**ADDENDUM NUMBER: TWO**

**PROJECT: VEHICLE STORAGE BUILDING  
REGINA, SK**

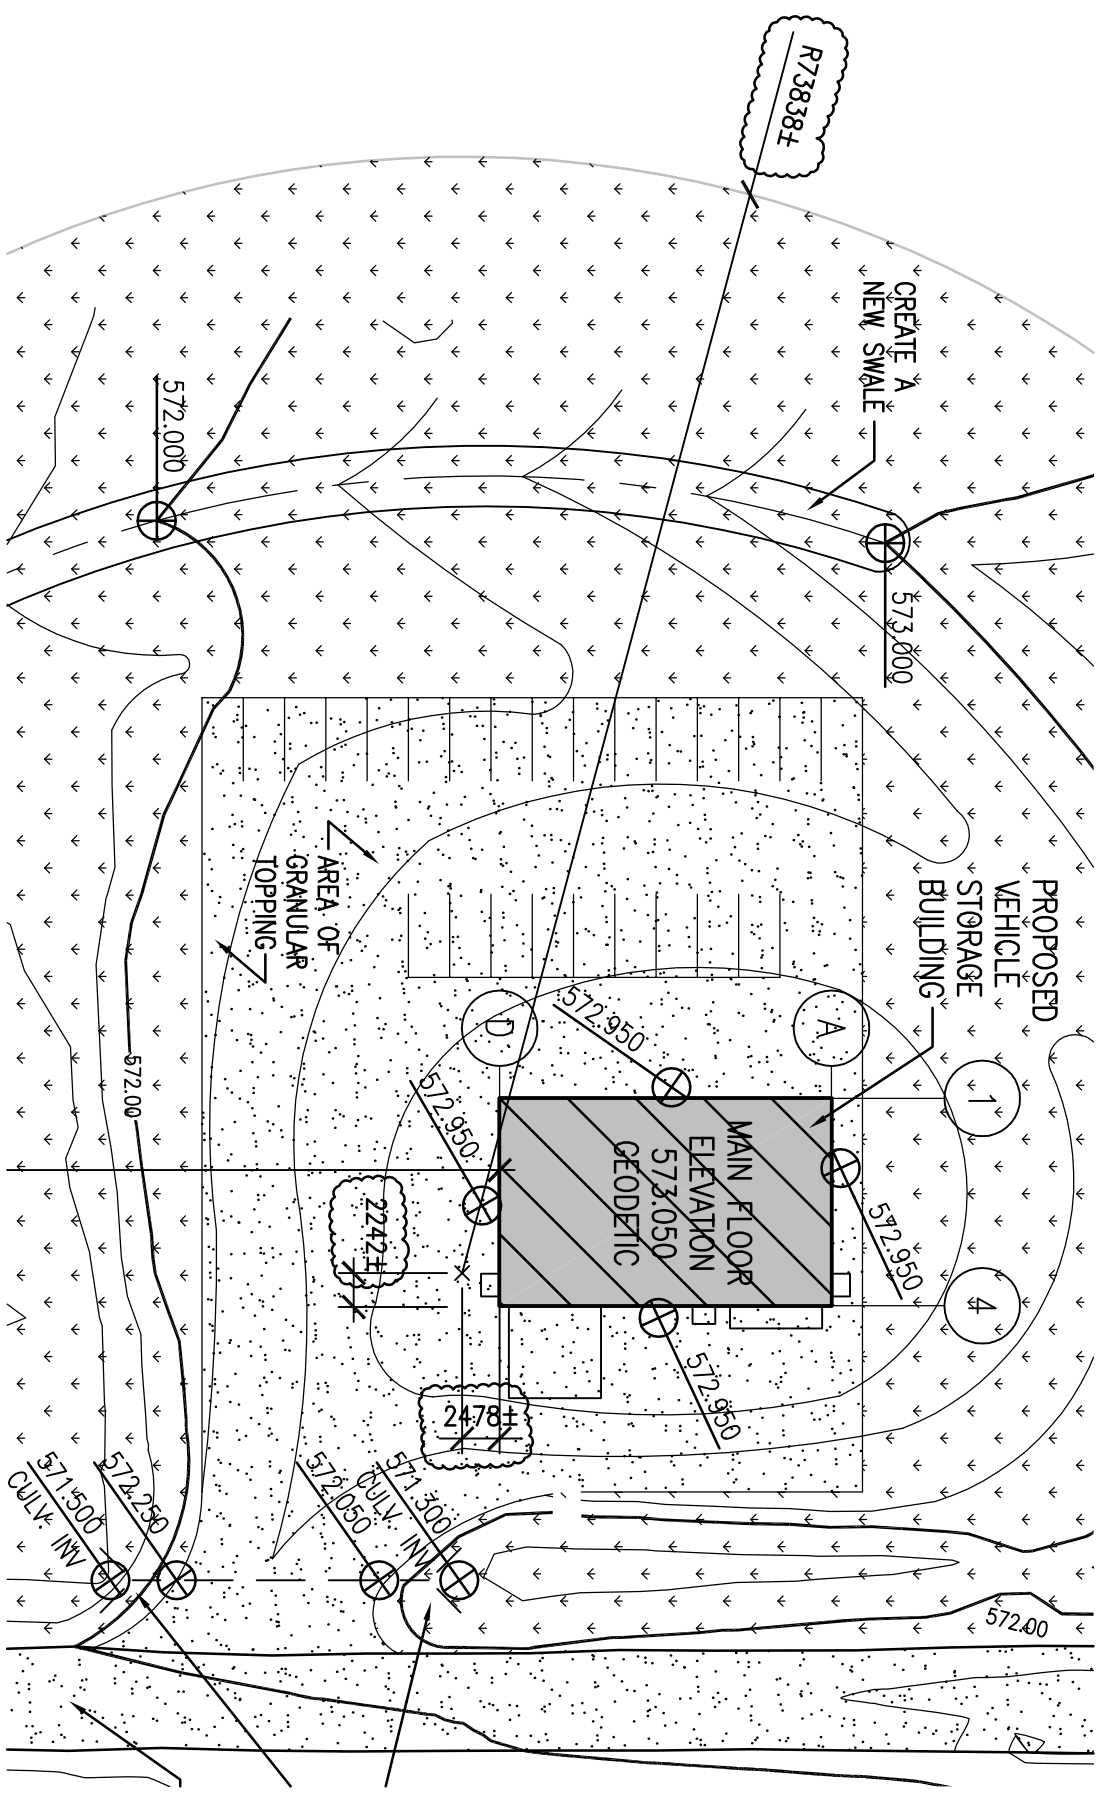
- .1 Reference Drawing 2, Revised Site Grading; Refer to Drawing AR02, appended to this addendum, for dimensions referencing approximate extent of disturbed soil.

Removed Soil Location

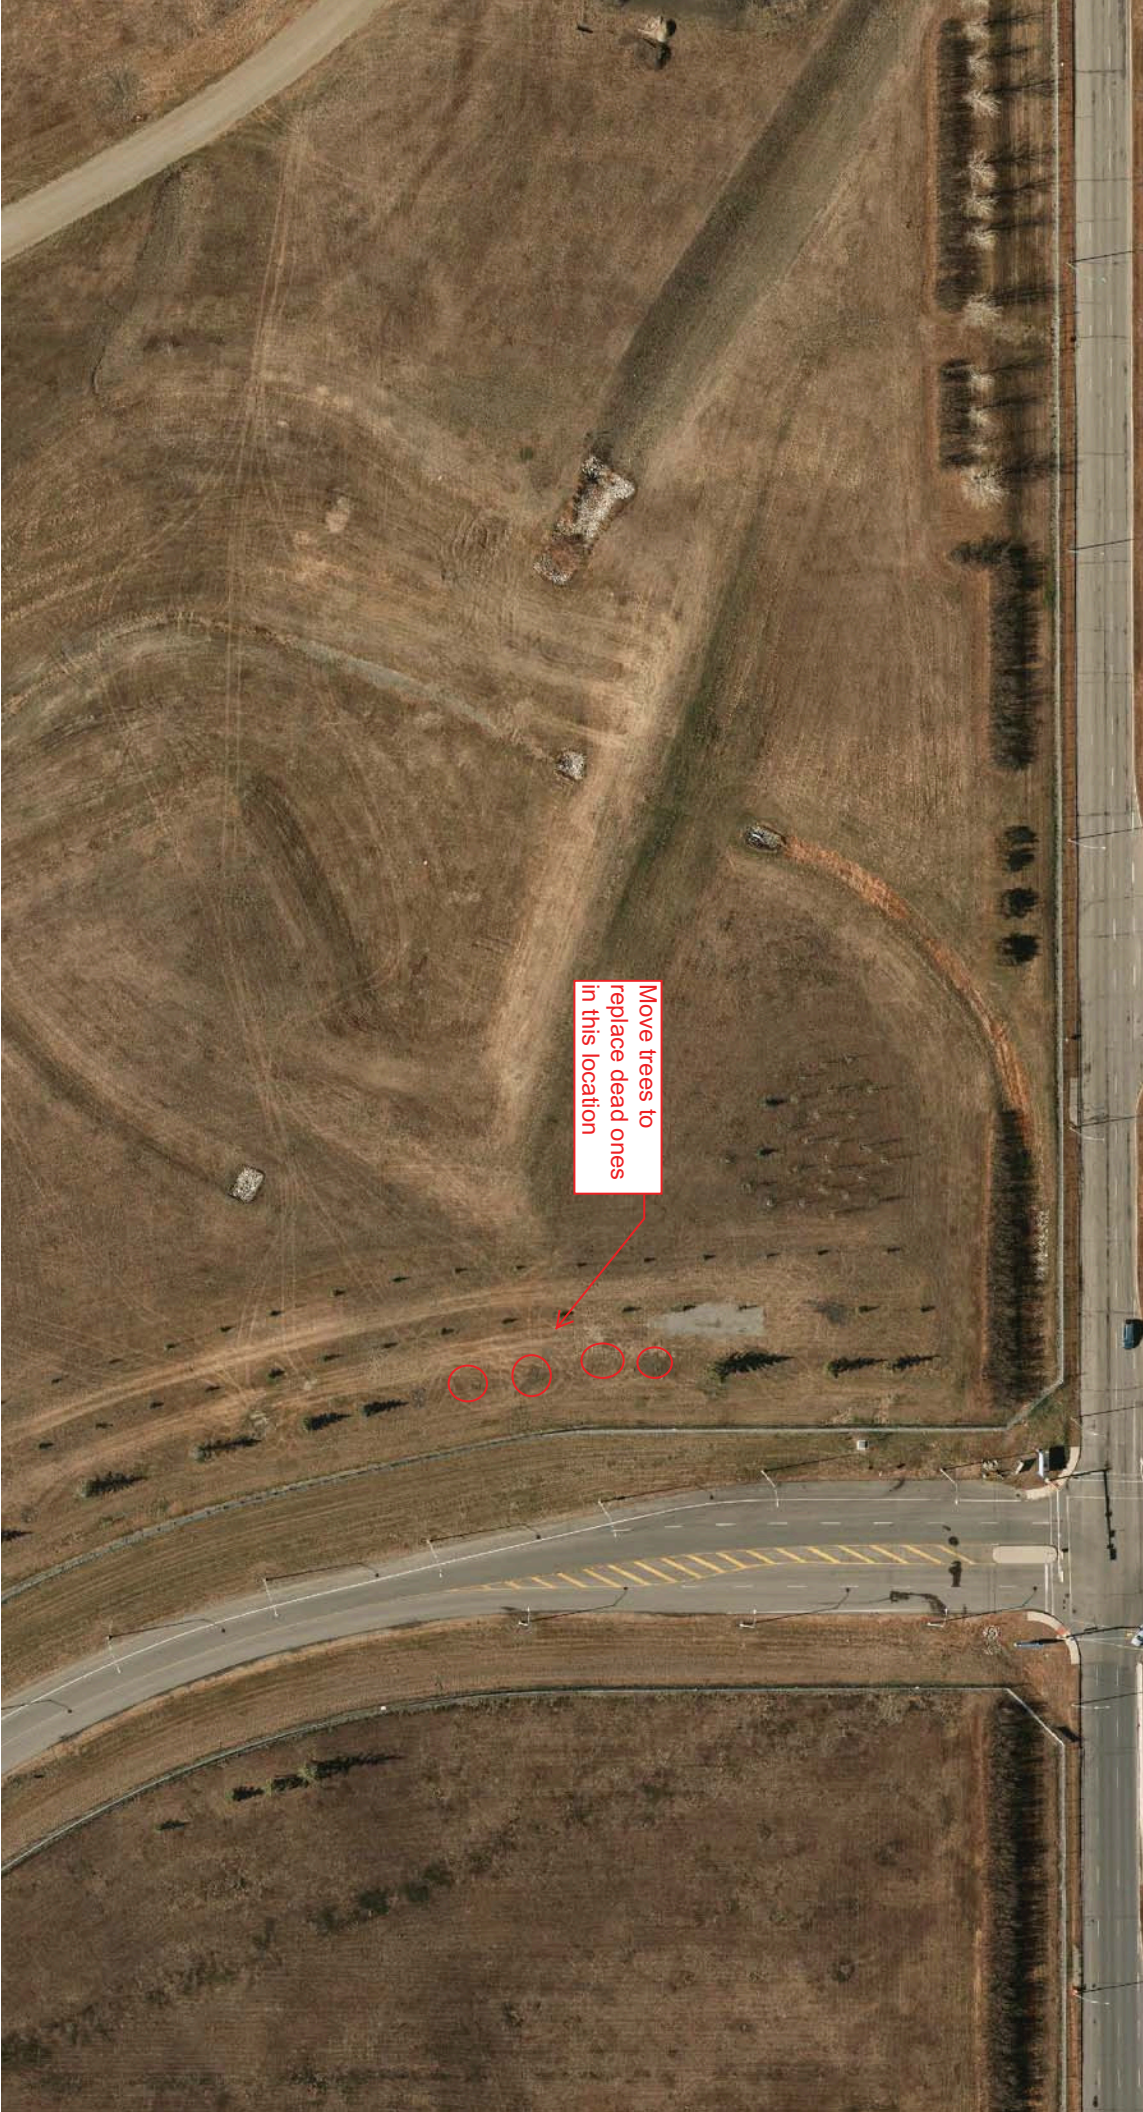
- .7 Reference Drawing 2, Site Plan; the removed soil is to be evenly spread out on the north berm and as directed by the Departmental Representative. Refer to ‘Removed Soil Location’ aerial image appended to this addendum.

Excess soil from here to be  
moved to any low area on  
North Berm and spread
